Addendum Number Five
To The Drawings and Specifications for
EMS Post #1
RFB Bid Number: 26-0035, Sedgwick County, Kansas

Issued: September 22, 2026

You are hereby instructed to include in your bids the following changes and/or corrections to the Drawings and Specifications for the **Construction of the New EMS Post #1 – 3099 W. 13th Street North, Wichita, Kansas 67203.**

SHEET
A6.1
OF 1 SHEETS

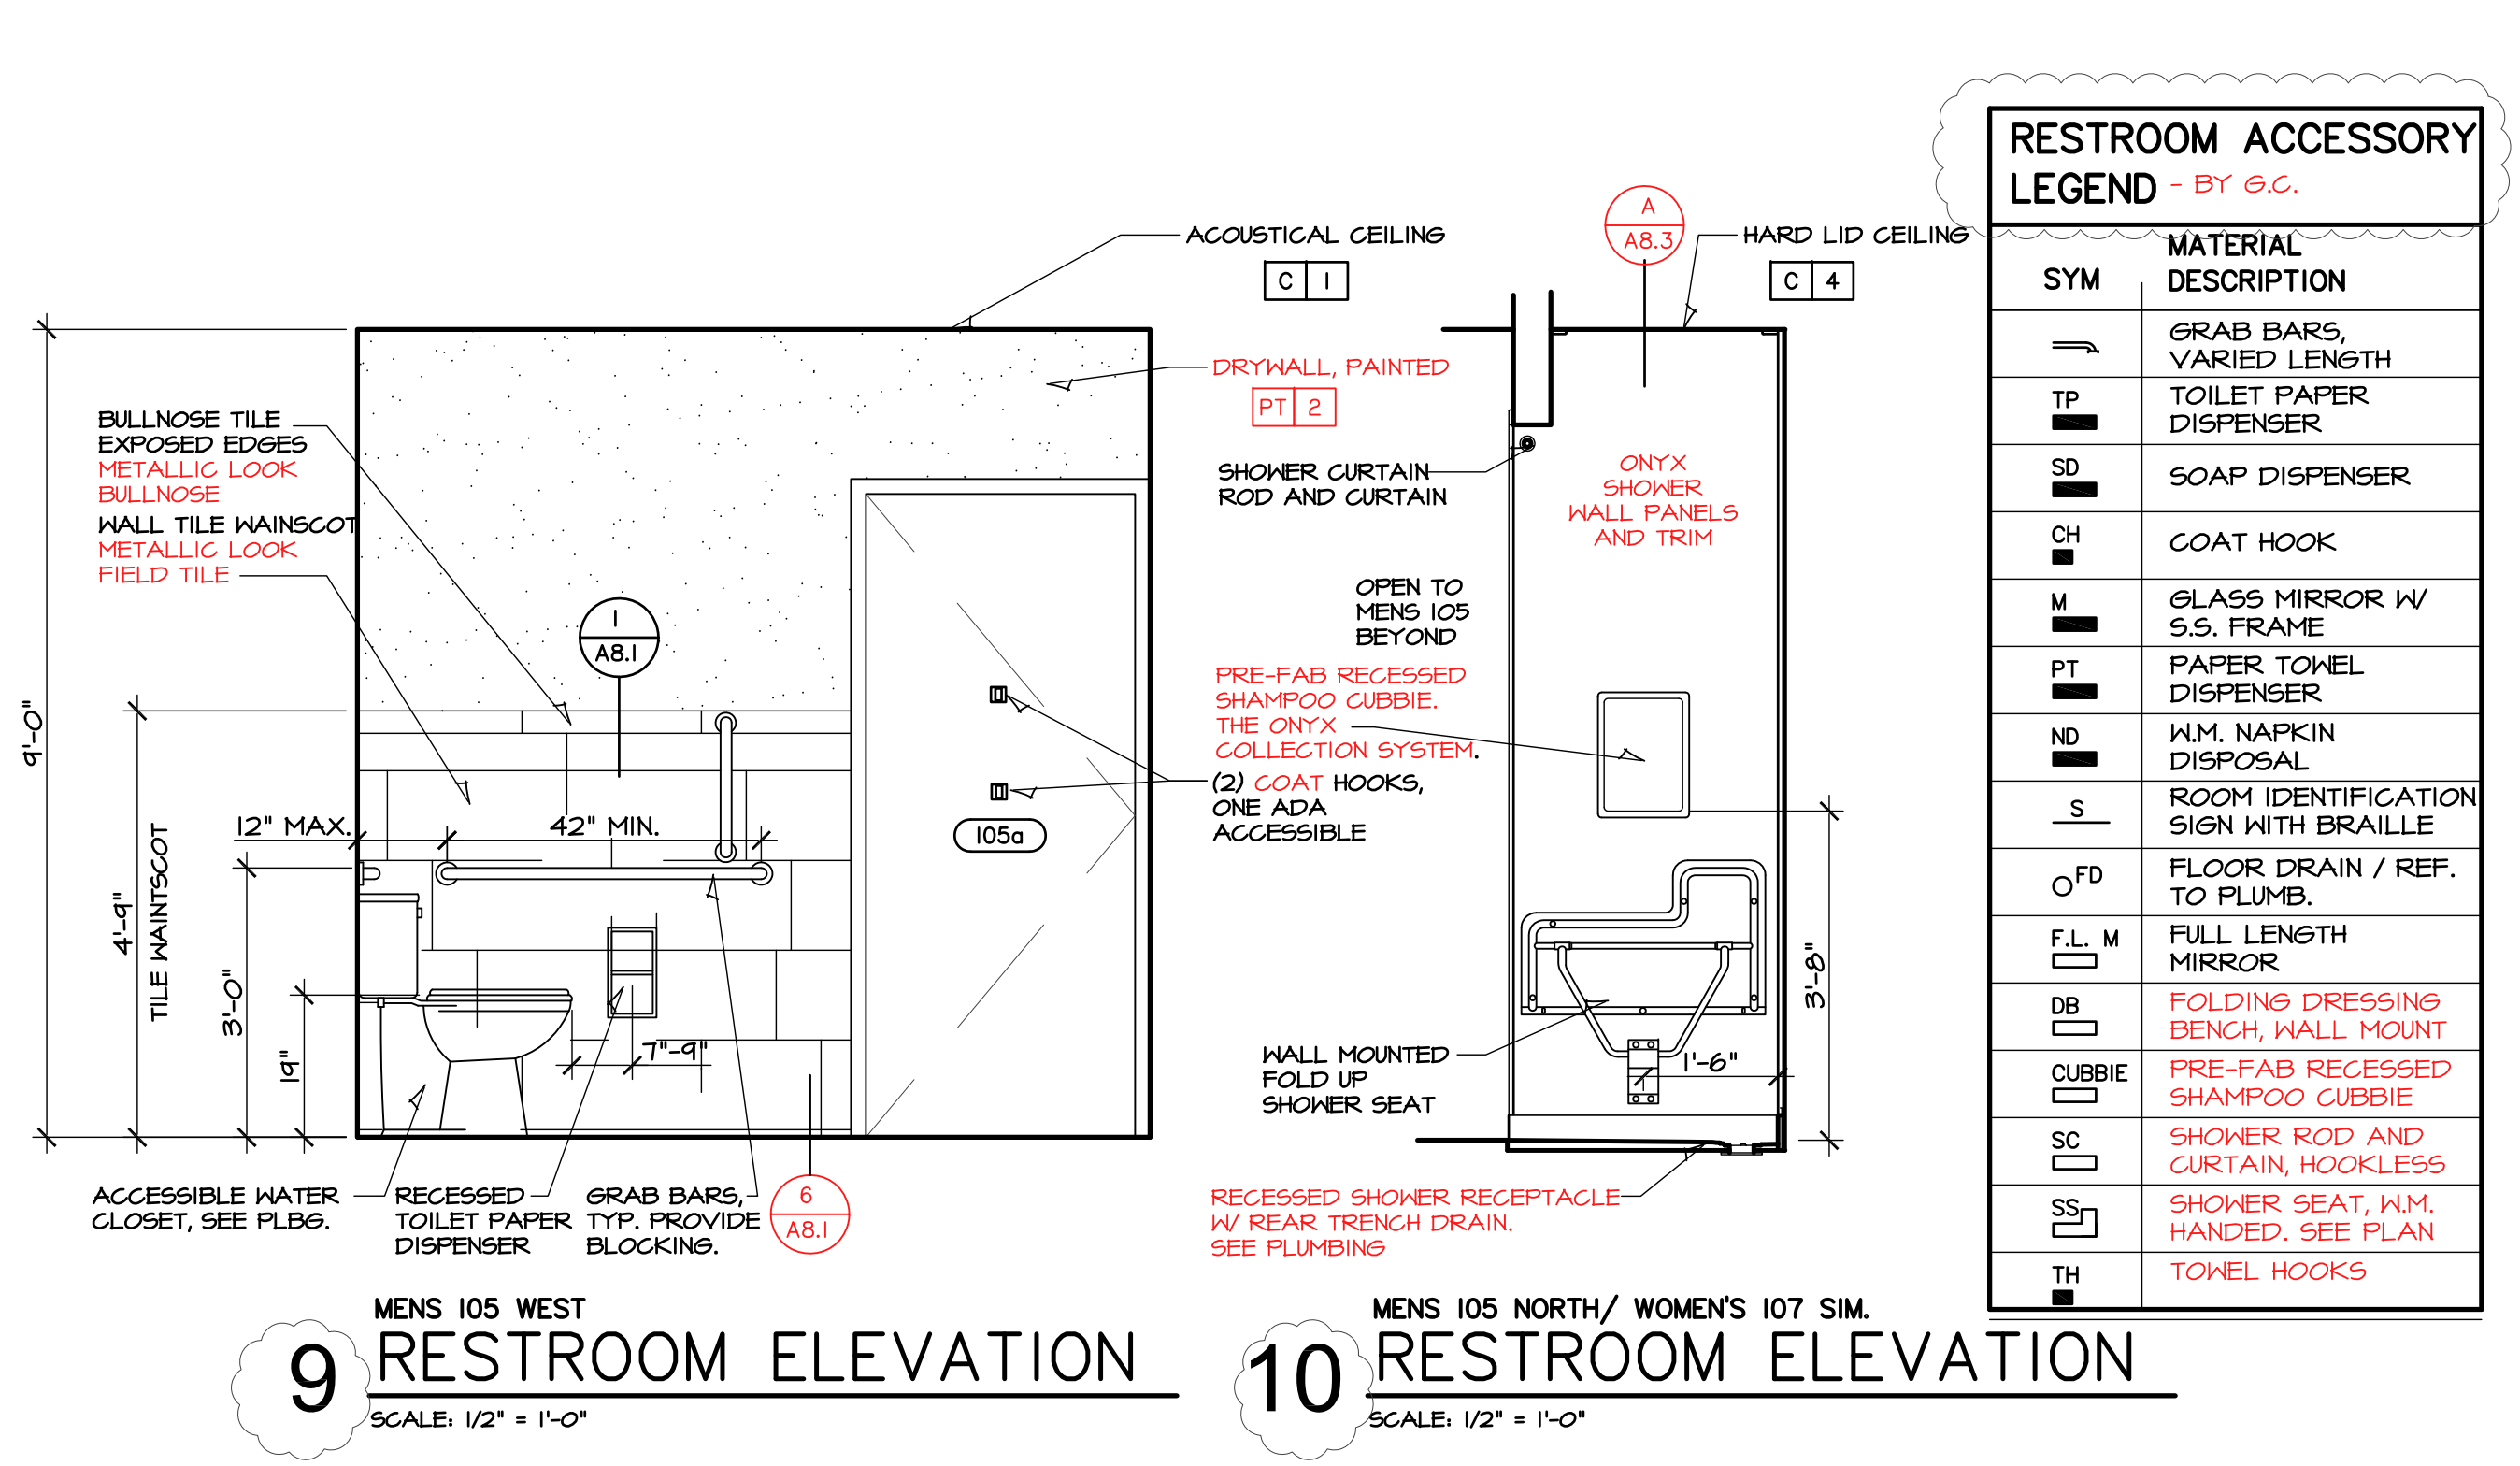
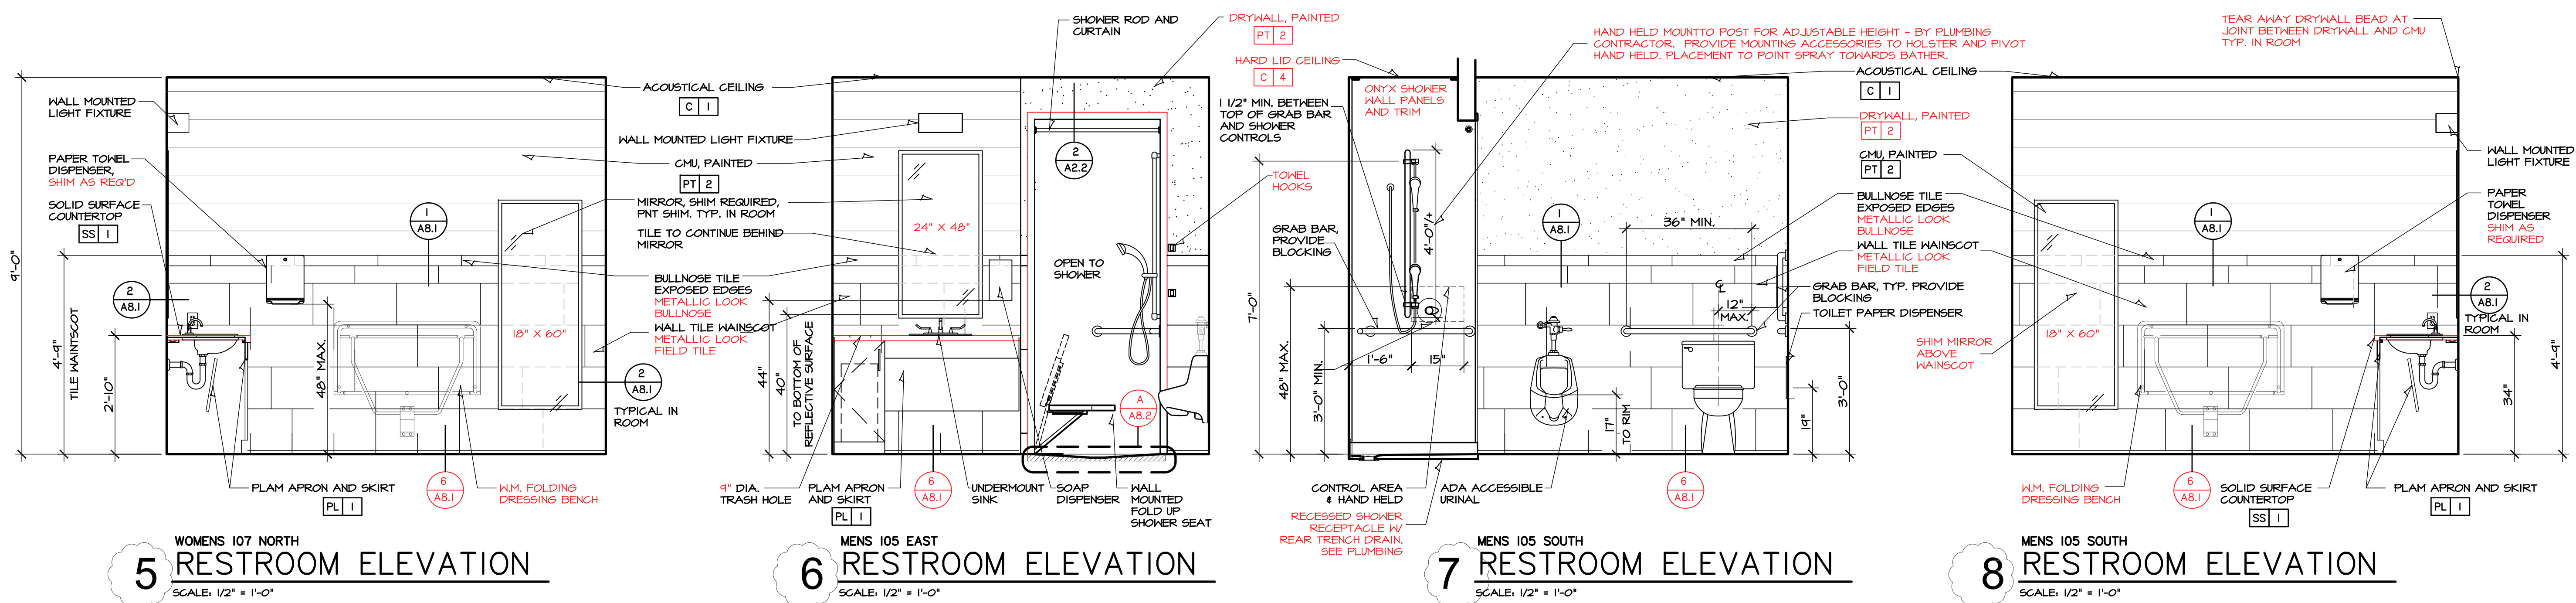
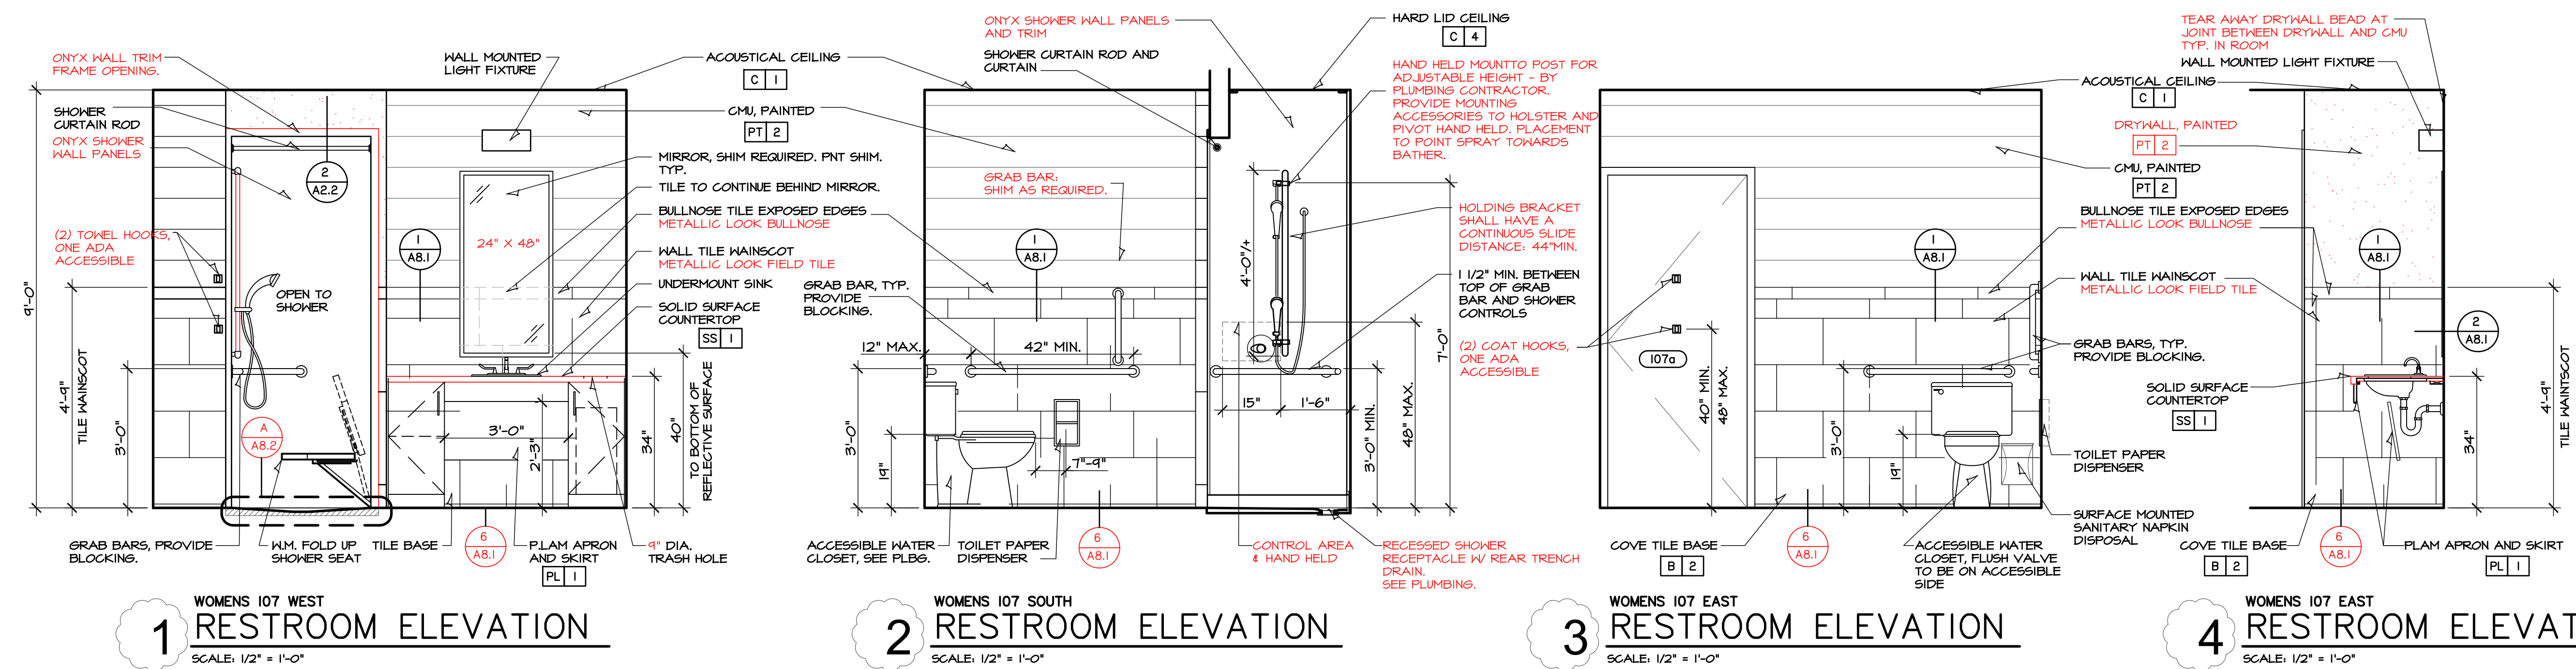
- d. Add sub-paragraph 9.3. – Tile Product, Restroom walls.
 1. Refer to the revised Sheet A6.1 issued with this addendum.
 2. Basis of Design, Metallic look Porcelain, Square format (field cut to size) or approved equal.

Distributor: Arizona Tile, Contact: Bobby Zink, phone (303) 574-2990,
email: bzink@arionatile.com
 3. Product is a rectangular sized tile,
Product: Reflexion (Reflex). Field Color: Mercury. Size: 12 inches x 24 inches.
Finish: Metallic sheen. Include matching porcelain bullnose trim, apply to exposed edges. Bullnose size 3 x 12. Installation is horizontally staggered. Color and install for bidding purposes, verify with architect prior to ordering.
 4. Schluter Metal trim applied to floor/ base joint. See detail 6/A8.1.
 5. Wall tile wainscot height as noted, 4 feet 9 inches. Field Tile: Start full sized tiles above floor/base joint. (4) full height courses. Accent Color, Continuous Horizontal Band, for Top (2) courses as follows: Cut tile height plus bull nose trim tile. Accent color: Titanium.
 6. Shower walls are as noted on A6.1, A8.2 and A8.3, issued by this addendum.

- 3.9 Sheet A6.1 + A6.2
The shower and finishes have been corrected.
These sheets are being reissued with this addendum.
- 3.10 Sheet A8.2 + Sheet A8.3
These sheets are being reissued with this addendum, detailing the shower.
